UNITED STATES  
NUCLEAR REGULATORY COMMISSION

SUBJECT: SUMMARY OF MEETING ON JUNE 23, 2005, WITH THE TECHNICAL  
SPECIFICATION TASK FORCE

**NRC Technical Specifications Section (TSS) Comments  
on the TSTF Proposed Process for NRC Review of T-Travellers**

# STS GENERIC CHANGE PROCESS

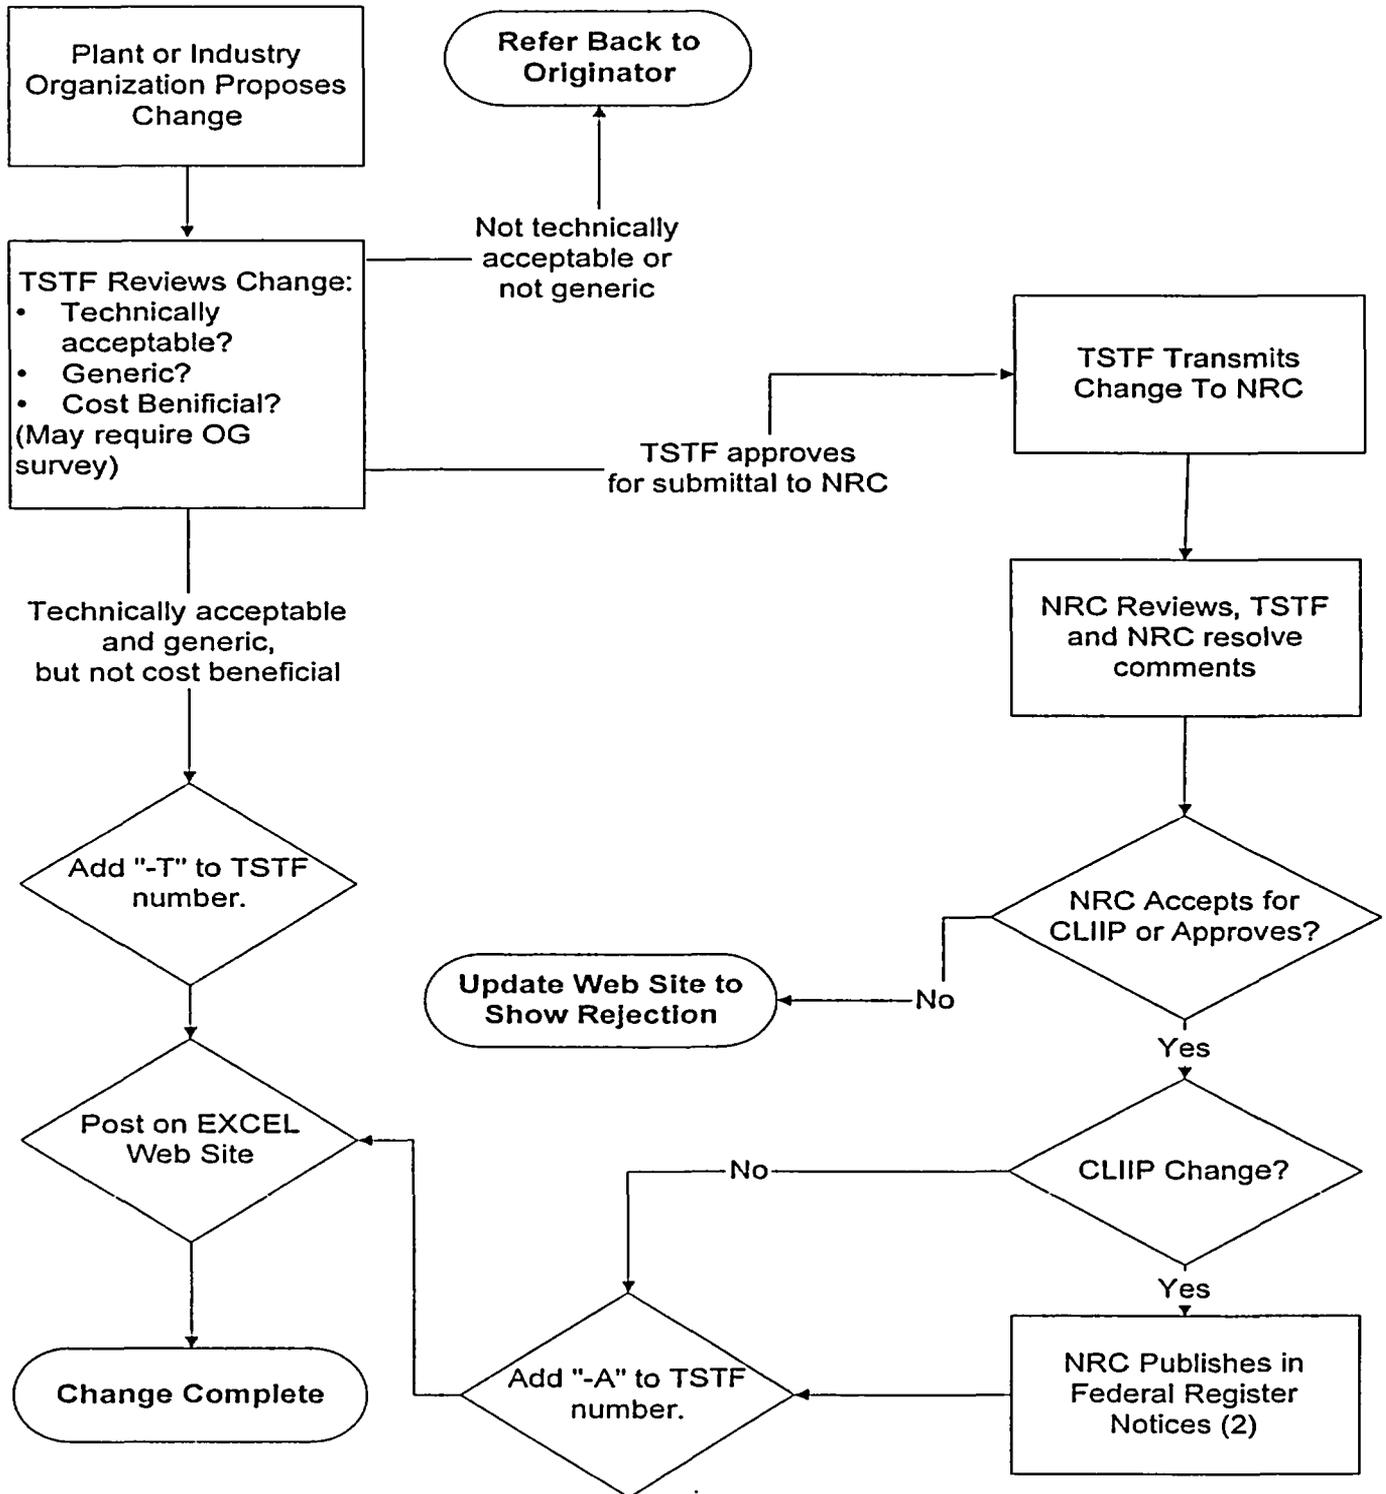
2. For further discussion: A flow path on the chart is desired to address proposed TS changes that are of low significance or not worthy of a separate TS change, such as administrative changes to the STS. Conceptually, this flow path may not result in a separate safety evaluation (SE), but the change may be adopted during a subsequent revision to the STS. The decision involving the SE and the adoption of the change in the STS Revision is determined by the TSS. Some controls on STS configuration would need to be put into place.
